Vermont Agency of Transportation  
**RECEIVED**  
 CK'D BY MEM OK'D BY CWC  
 Apr. 16, 2015  
 RESUBMIT APPROVED AS NOTED ✓  
 BY C. Carlson DATE 05-06-2015

ITEM 525.33 2-RAIL BRIDGERAIL GALVANIZED  
 BRIDGE REHABILITATION  
 RT. 116 OVER LITTLE NOTCH CREEK  
 R.I.N. #6 P.I.N. BR 021-1 (29)  
 TOWN OF BRISTOL, ADDISON COUNTY

GEN. CONTRACTOR: 2040  
 SHEET NO.: 2 of 4  
 SUB CONTRACTOR: LAFAYETTE  
 DRAWN: MKT CHECKED: DATE: 04-15-15 SCALE: NONE SIZE: D

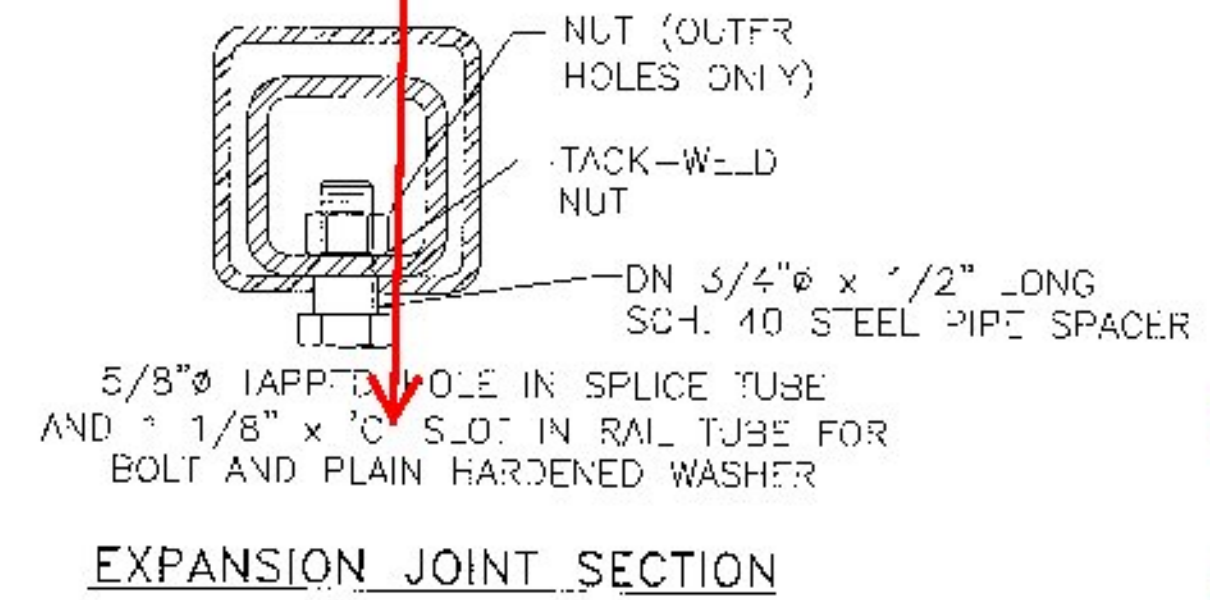
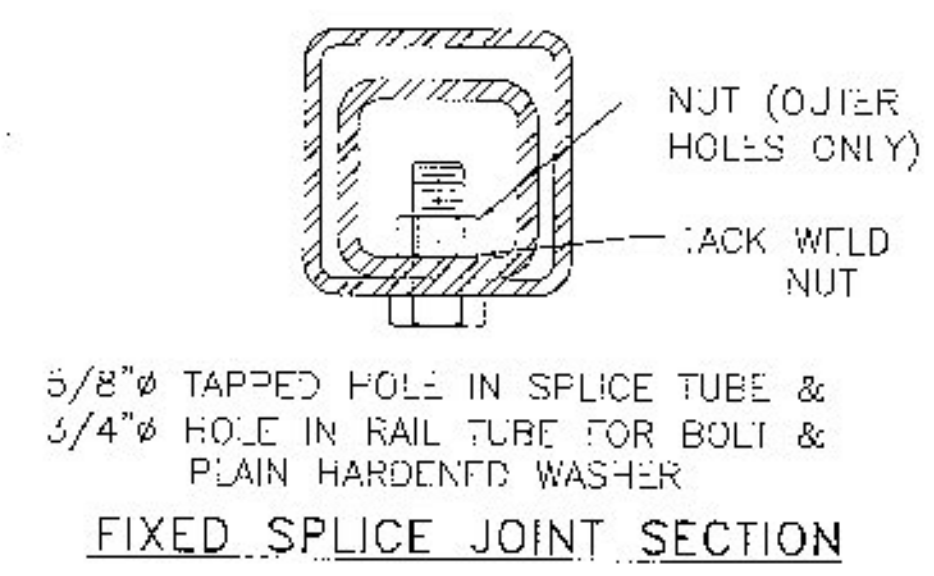
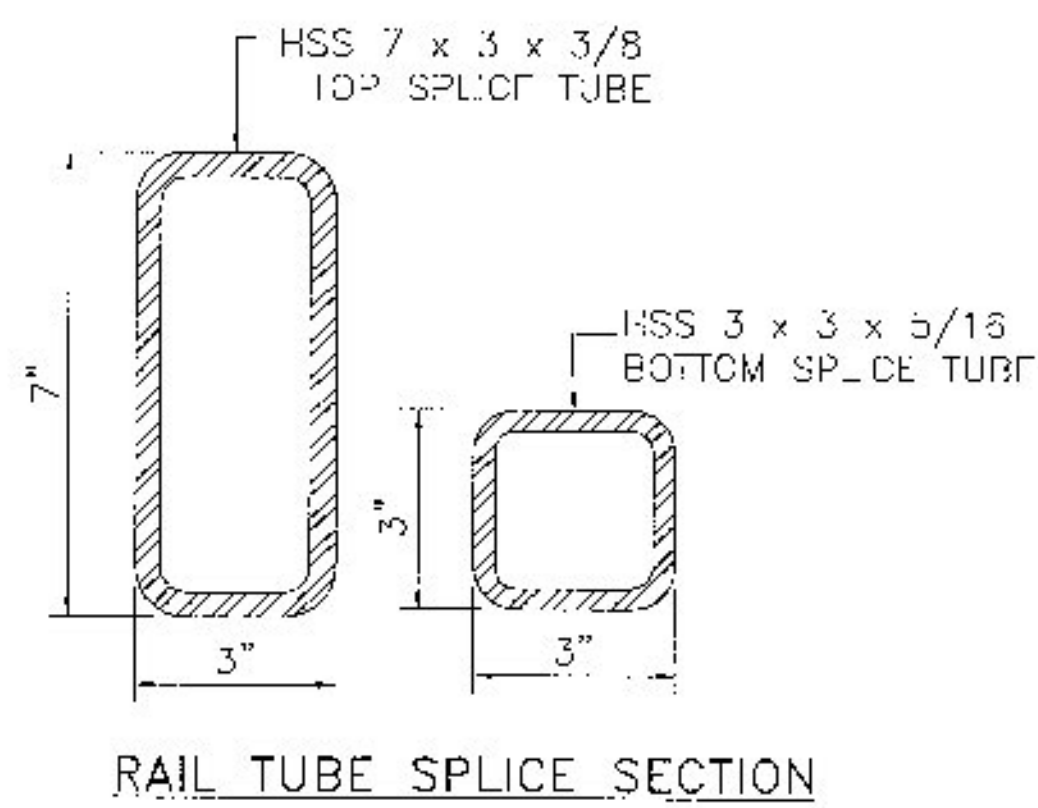
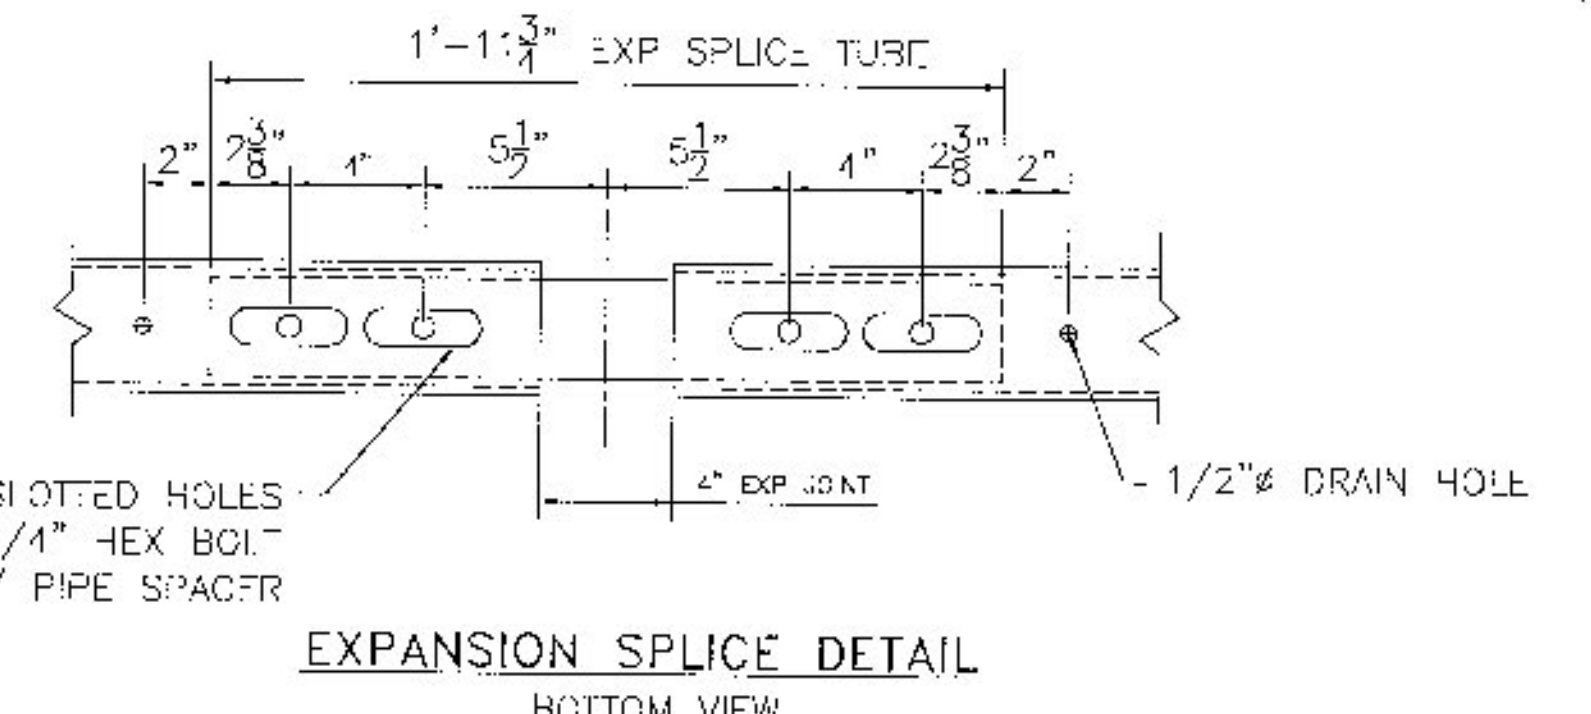
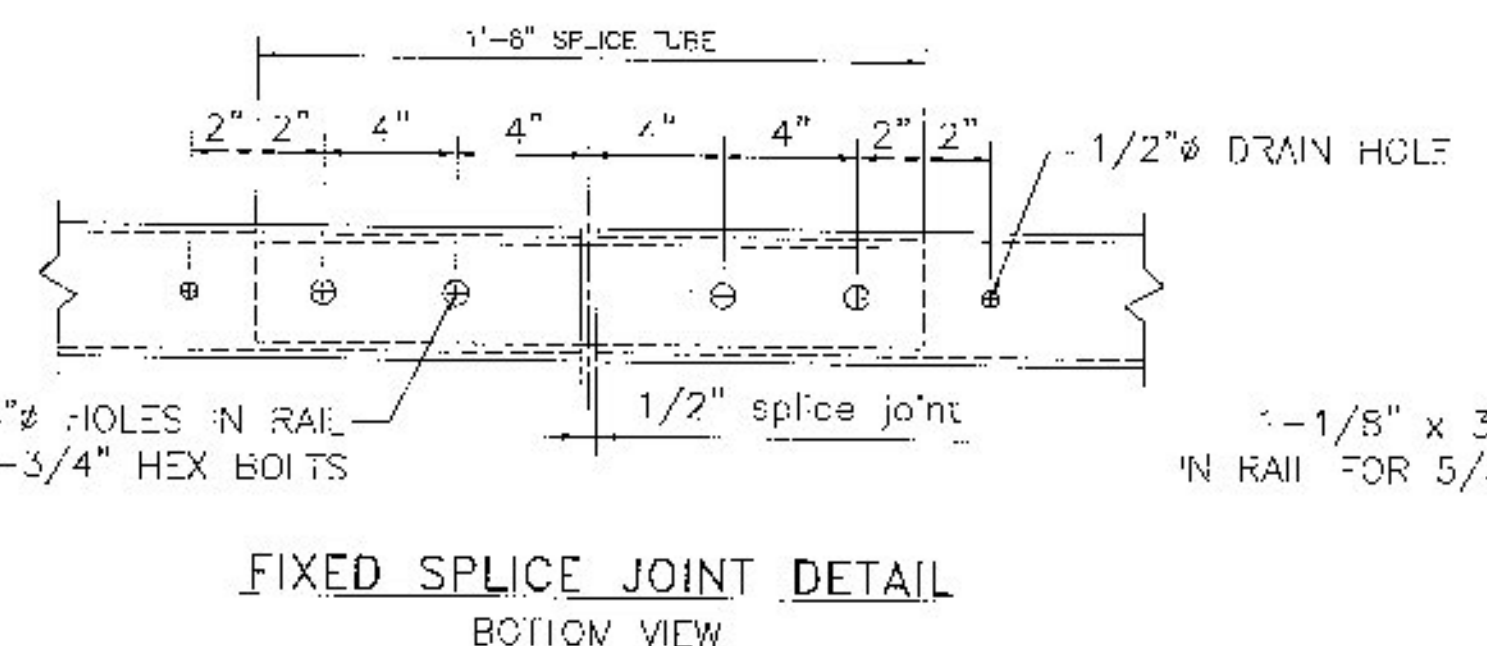
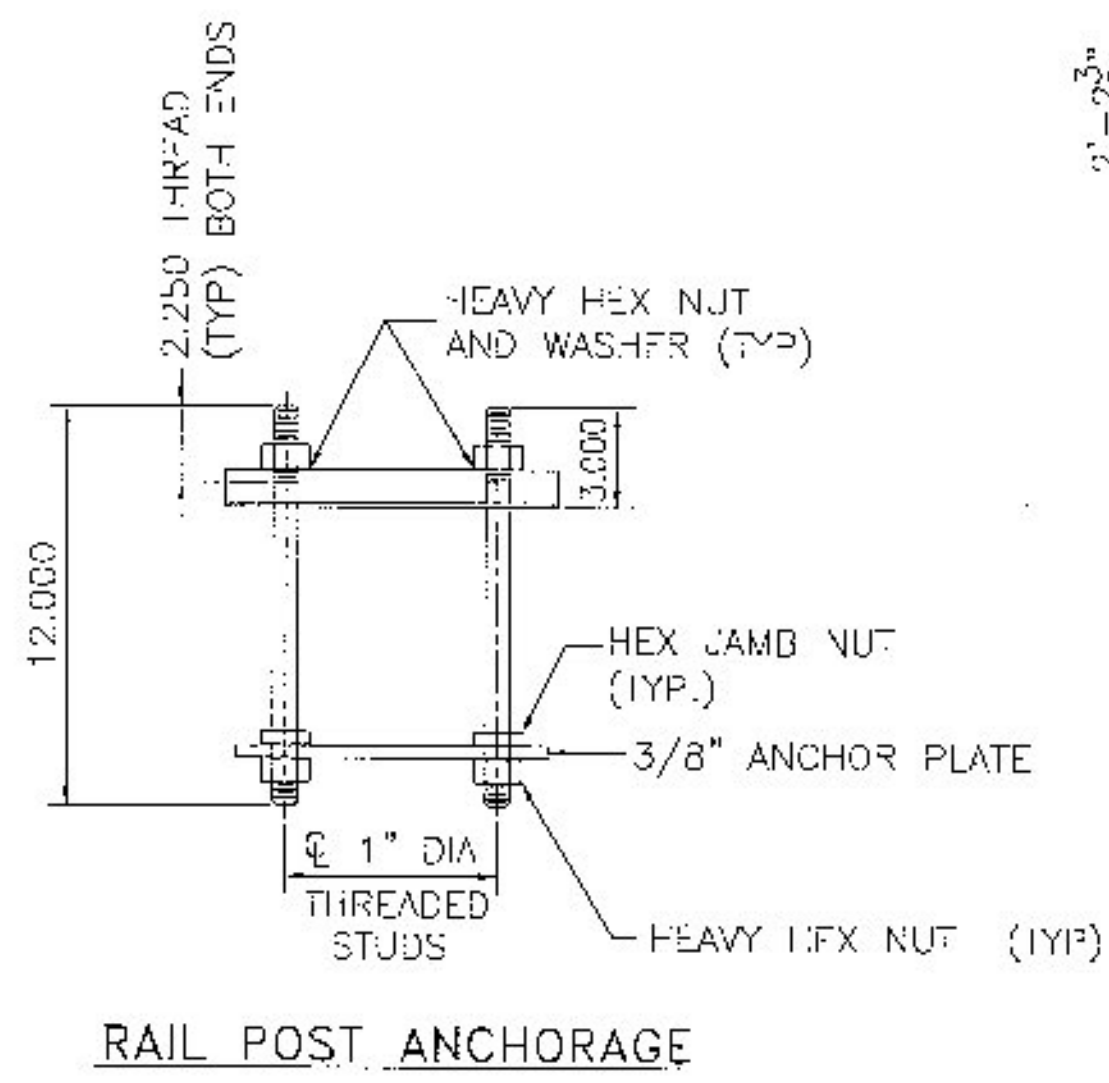
where is "C" specified? should be 3 1/2"
